UNITED STATES
NUCLEAR REGULATORY COMMISSION
WASHINGTON, D. C. 20555

March 28, 1980

Docket No. 50-409

RE: ENVIRONMENTAL QUALIFICATION OF ELECTRICAL EQUIPMENT

FIGURE 1

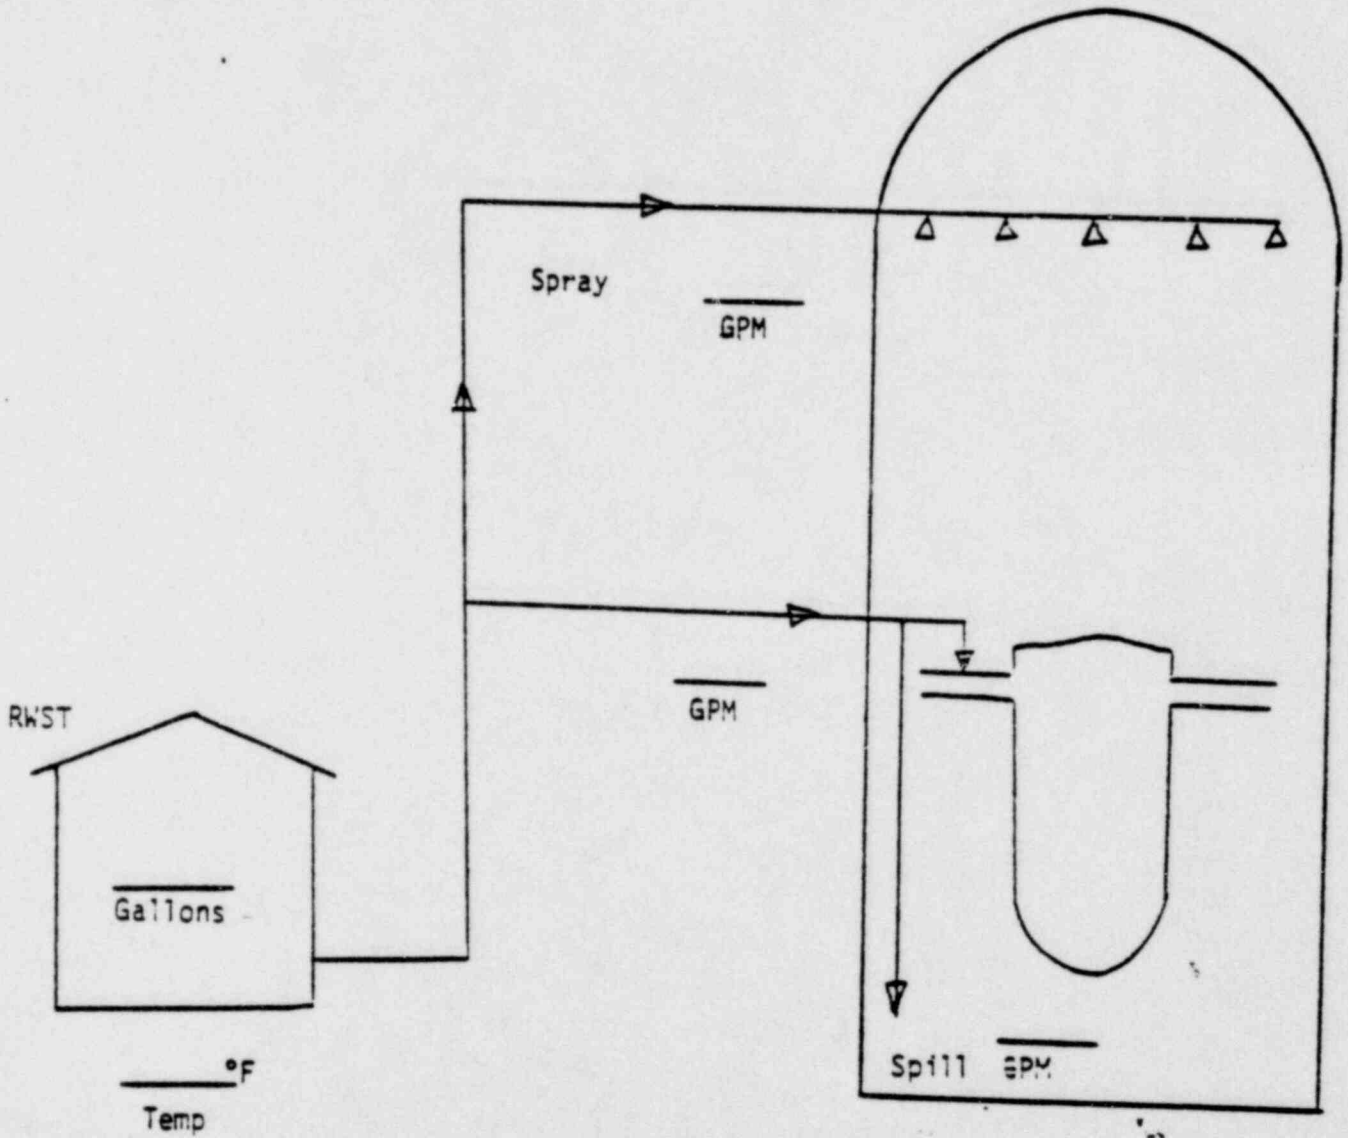
II. Figure 1 and 2 represent typical ECCS and spray systems relied on to mitigate the consequences of a pipe break. Provide the information indicated in the figures; if the plant specific systems differ from the attached figures, revise the drawings to represent your facility and provide the appropriate information.

When providing system parameters, indicate whether the values given assume a single failure and specify the single failure assumption.

FIGURE 1 - INJECTION PHASE

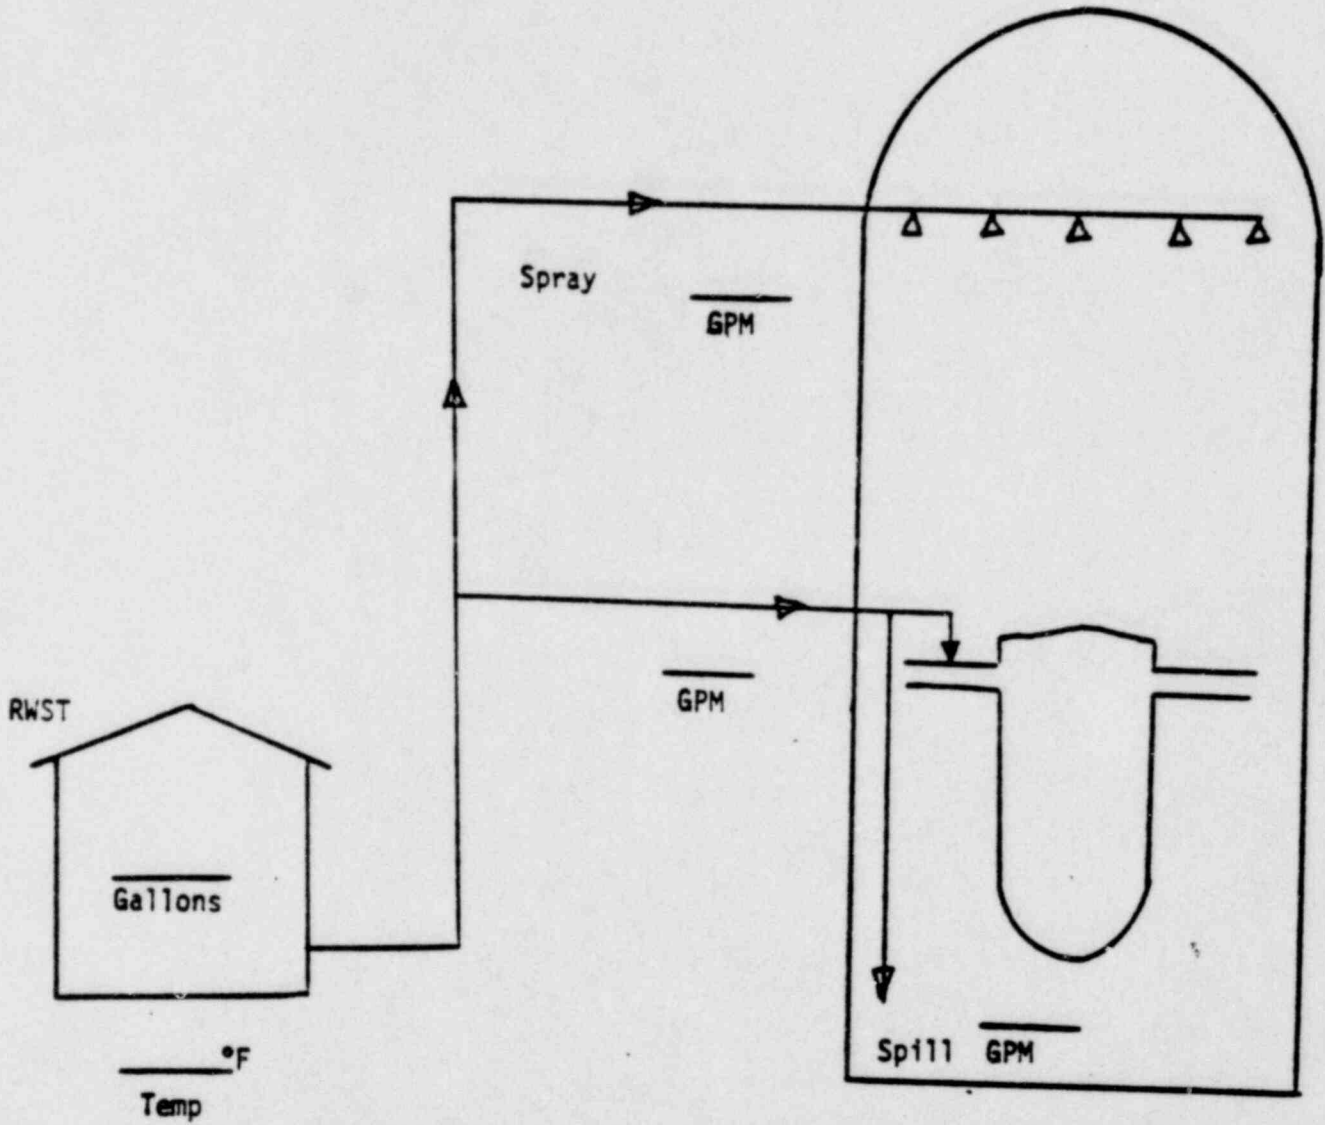
When providing system parameters, indicate whether the values given assume a single failure and specify the single failure assumption.

Figures 1 and 2 represent typical ECCS and spray systems relied on to mitigate the consequences of a pipe break. Provide the information indicated in the figures, if the plant specific systems differ from the attached figures, revise the drawings to represent your facility and provide the appropriate information.
